Access Compliance Report Public Rights-of-Way (Pedestrian Signals)

Main Street: **NEWPORT_AVE** Cross Street: **17TH_ST** Location: **NW**

ADA ID: **SGRK211007130614** Signal Type: **One Push Button-Non APS** Overall Compliance: **No** Severity Scores: **BTN 1: 25** **BTN 2: N/A** **No BTN: N/A**

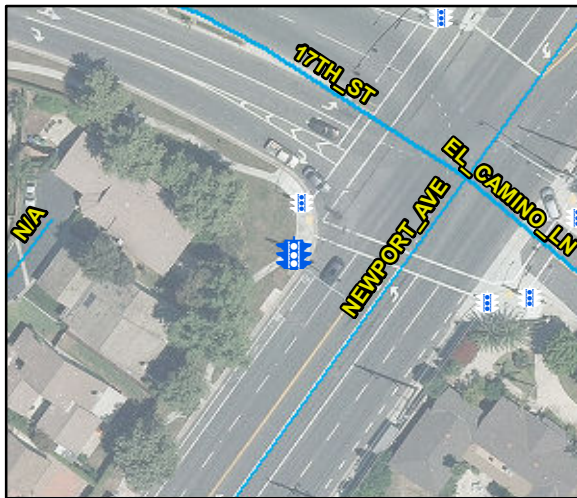
OC Std/PROW: **R404.2, R404.3**

Possible Solutions: Remove and Replace Clear Space.
